DESIGN ADVISORY BOARD Tuesday, June 23, 2015 at 3:00 PM Conference Room 12, City Hall, Burlington, VT

TO: Design Advisory Board
FROM: Scott Gustin
DATE: June 23, 2015
RE: 15-1314CA, 495-497 Colchester Avenue

Request: Raise building in place, insert additional story, and remove front porch. Retain 4 dwelling units and establish cafe.

495 COLCHESTER AVENUE BUILDING RESTORATION Burlington, Vermont

TITLE:
EXISTING WEST ELEV.
PROPOSED WEST ELEV.
SCALE: 1/8" = 1'-0"

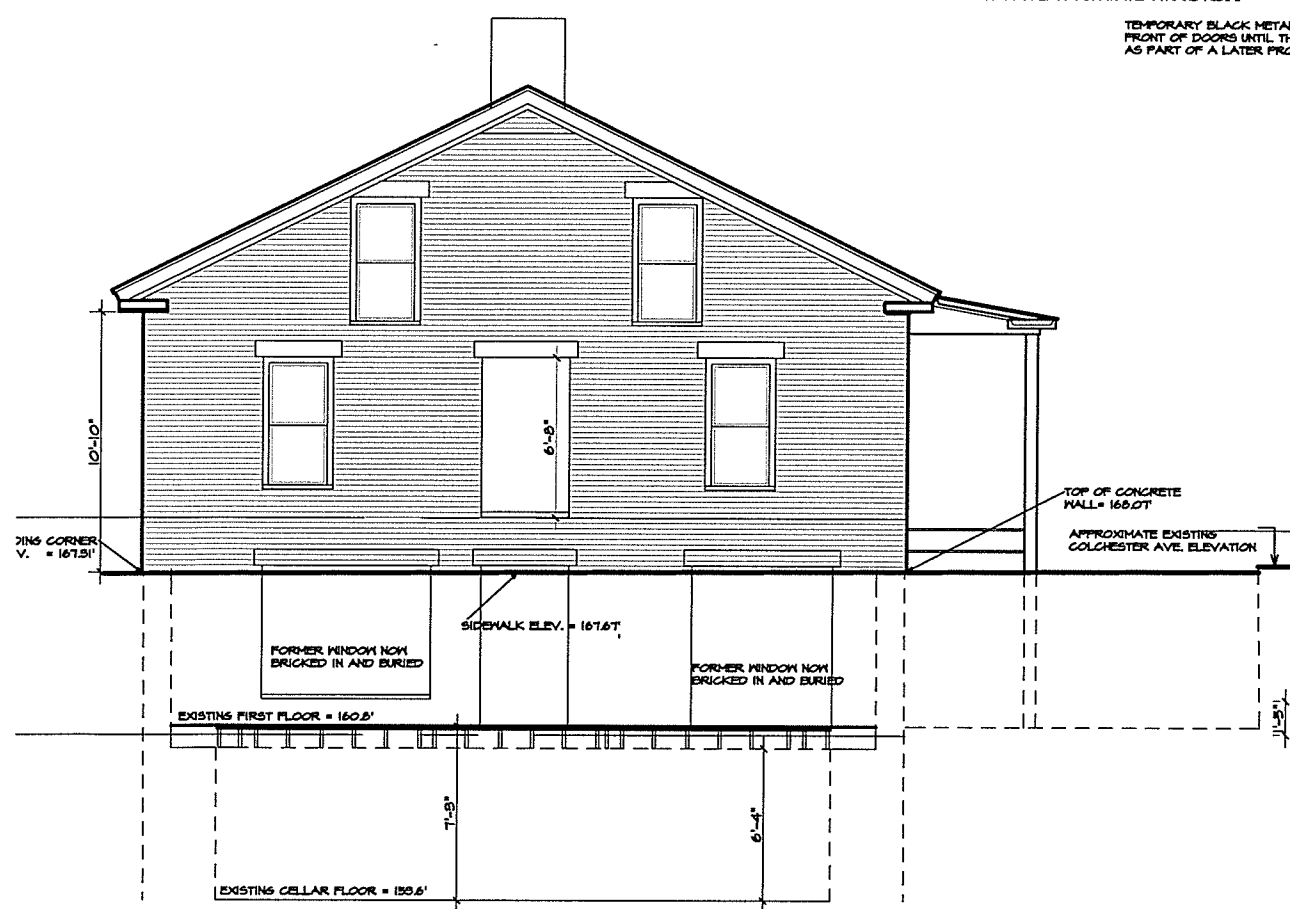
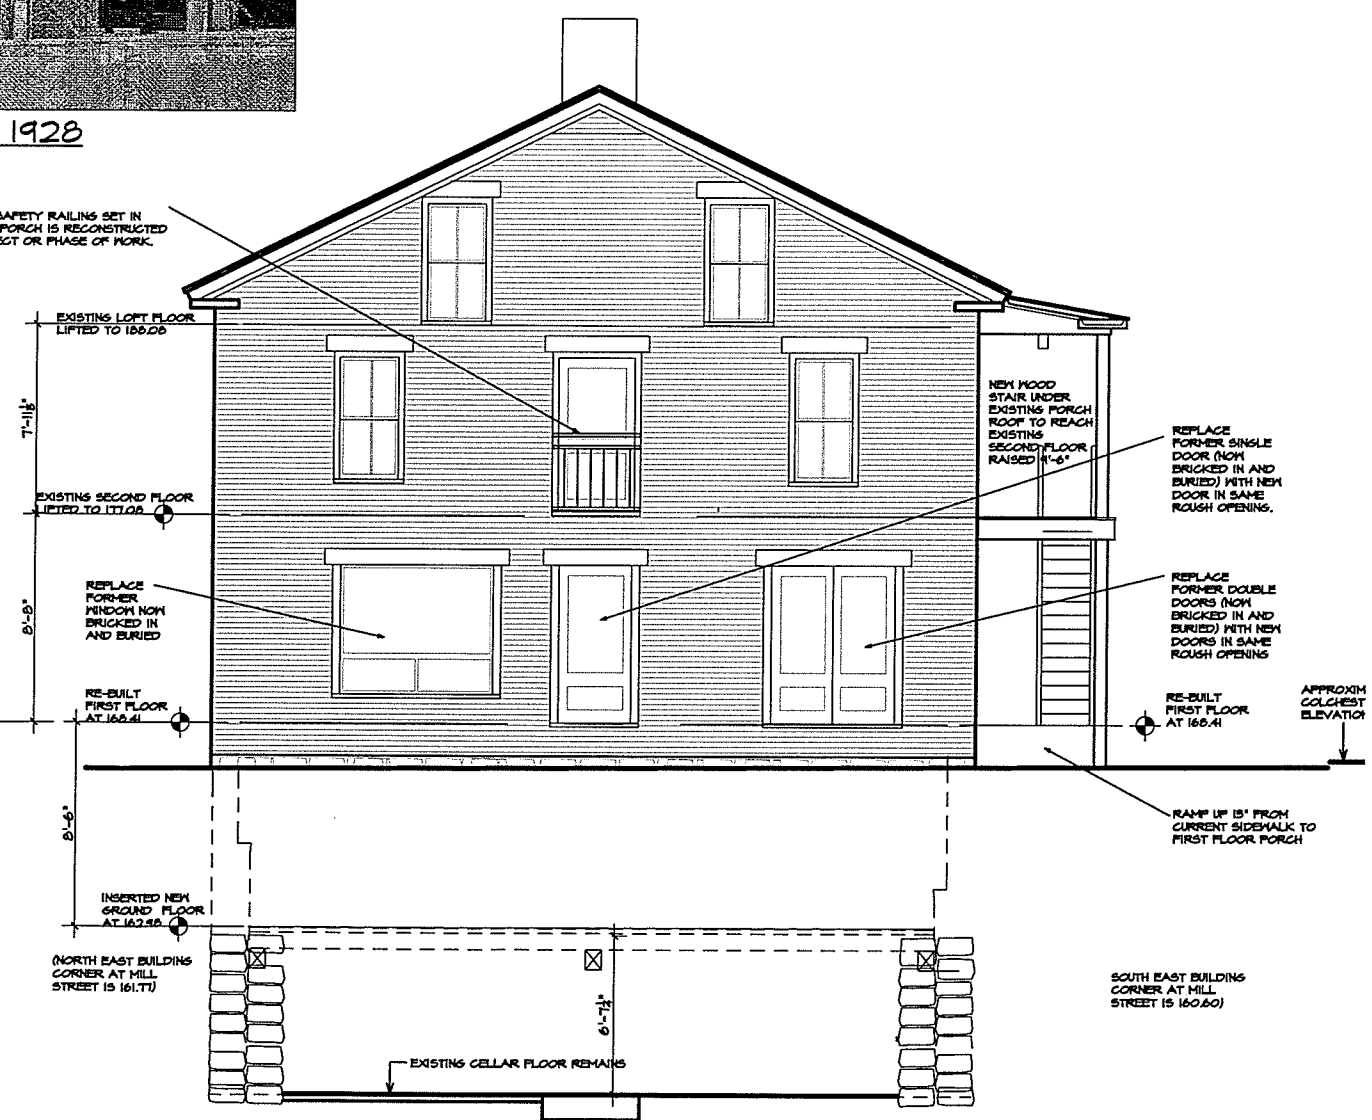
The proposed construction will liven the structure's Colchester Avenue frontage, reintroducing shopfront windows and doors that were buried following the 1927 flood. Note that the west elevation plans contain a labeling error, referring to buried windows versus doors on the existing versus proposed building elevation plans. The newly reintroduced doors on the west elevation are somewhat elevated above grade. Presumably, steps will be provided as the doors appear to be functional, but none are evident on the site or elevation plans. If so, an encumbrance permit from the Dept. of Public Works will likely be needed for encroachment into the street right-of-way.

1. Correct the labeling error on the west elevation plans (bricked-in doors vs. windows).
2. Note window and lintel materials.
3. Clarify whether a step or steps will accompany the re-installed doors on the west elevation.
4. Indicate the net new number of rooms constructed and associated off-street parking.

TITLE:
WINDOW DETAILS

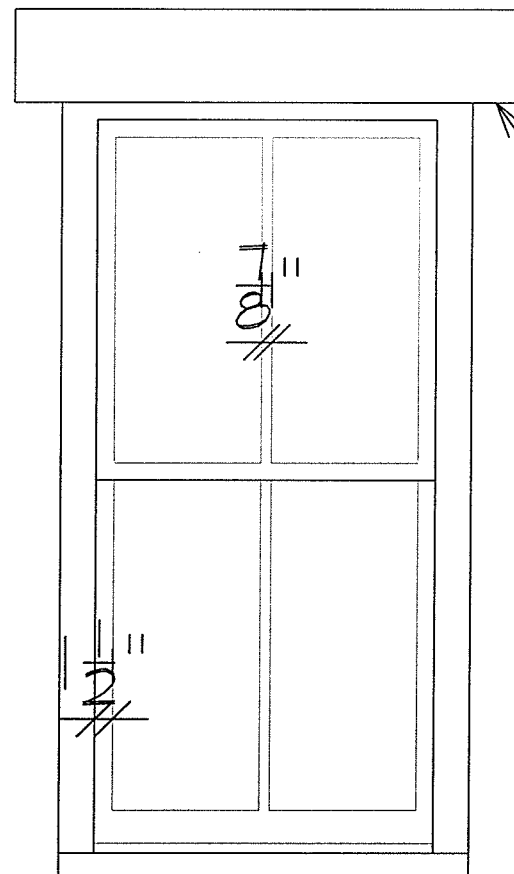
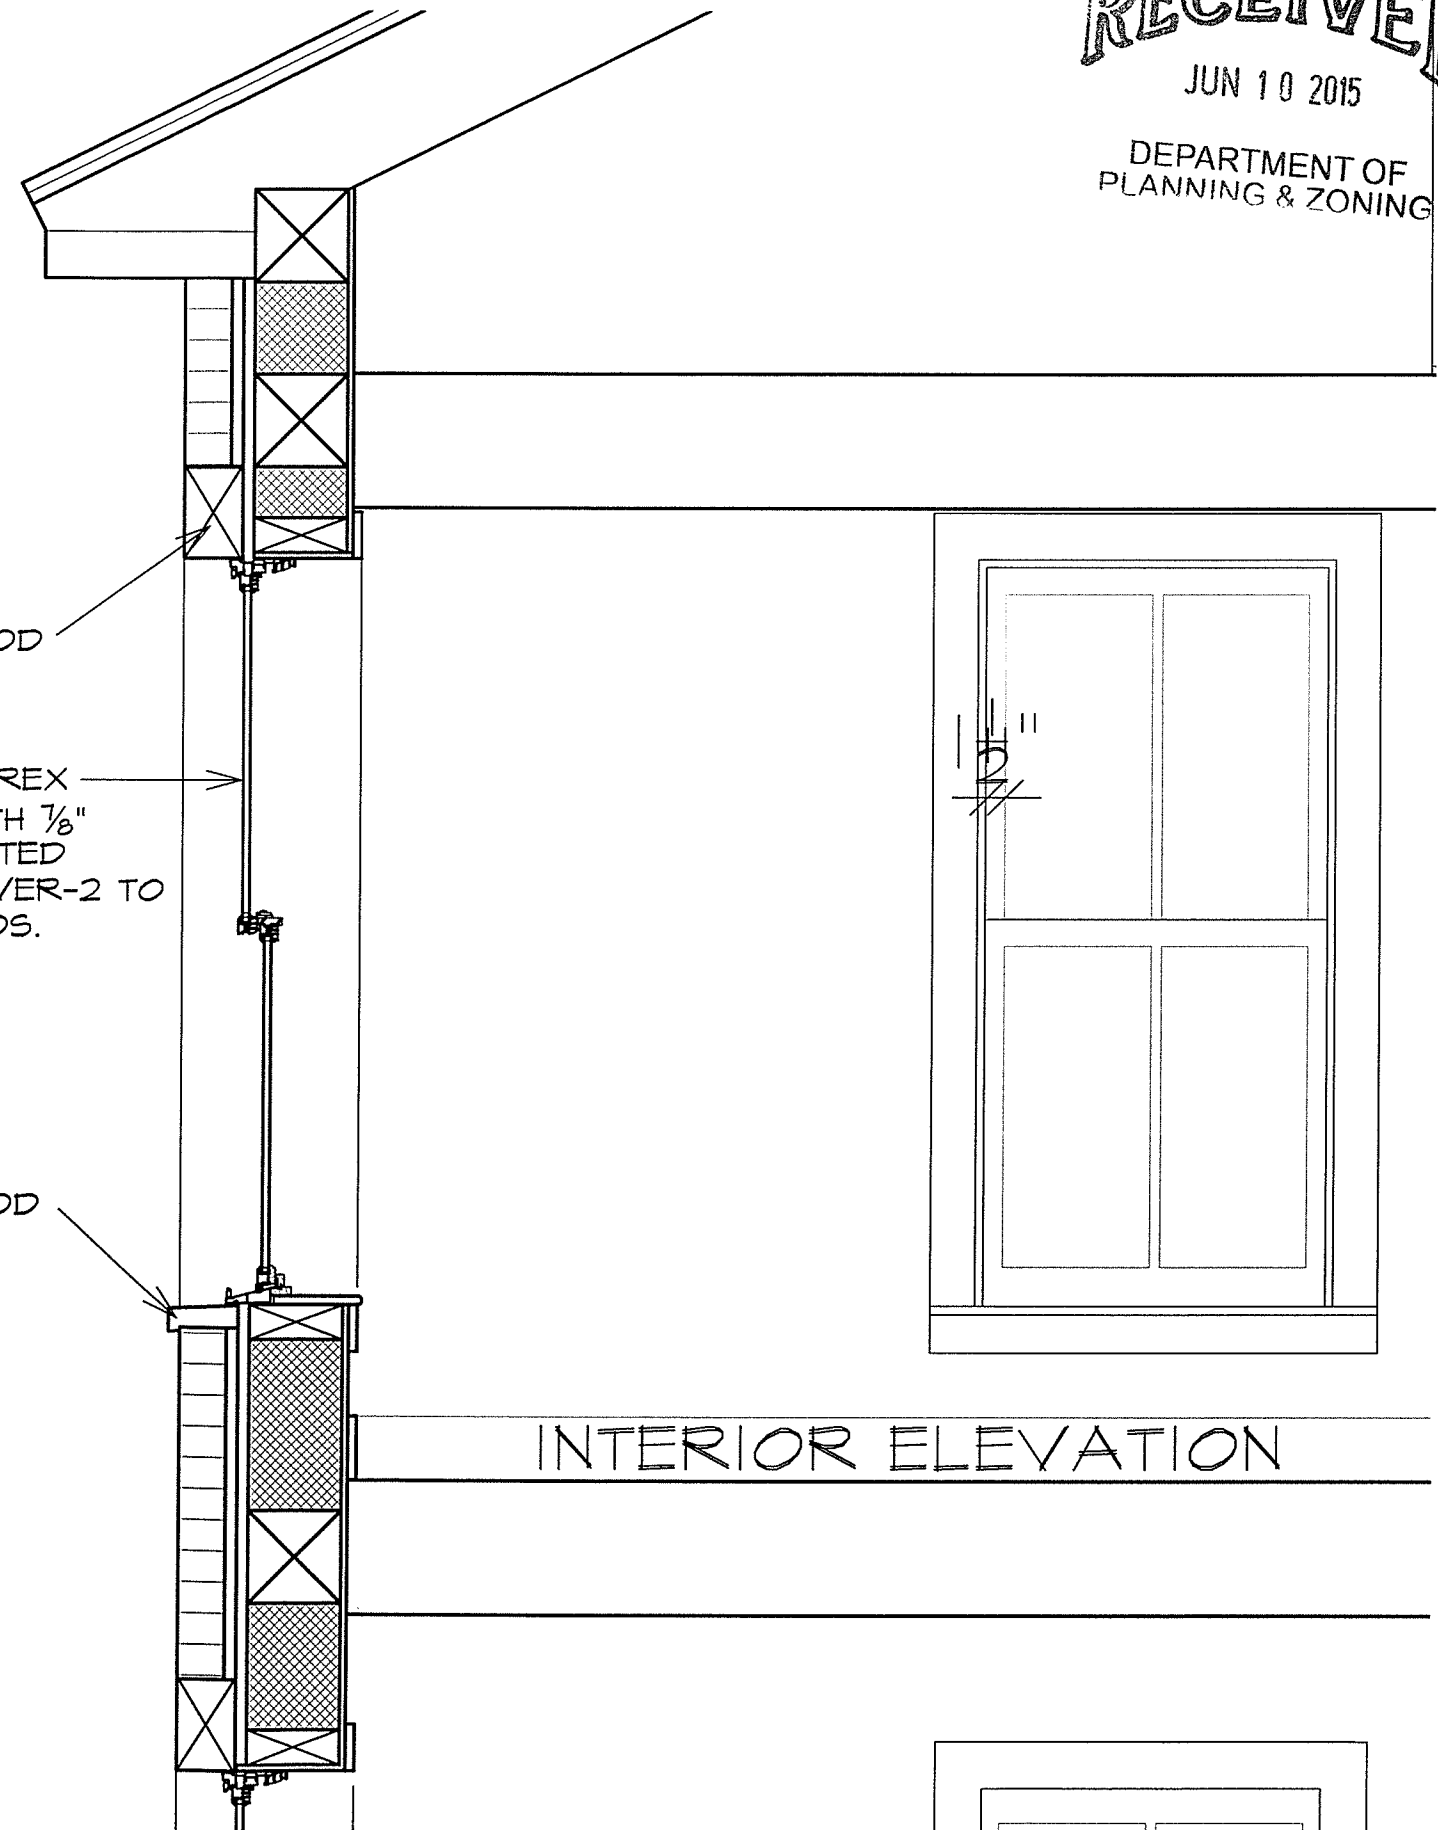
Existing brick veneer will be retained and filled in as needed. The newly inserted ground floor will be constructed of concrete, clad in stone veneer. New lintel materials are not noted and must be. Likewise, window materials are not noted and must be.

It appears that all such materials, features, finishes, and construction techniques represented by the original structure will be preserved. As noted previously, window and lintel material information is needed.
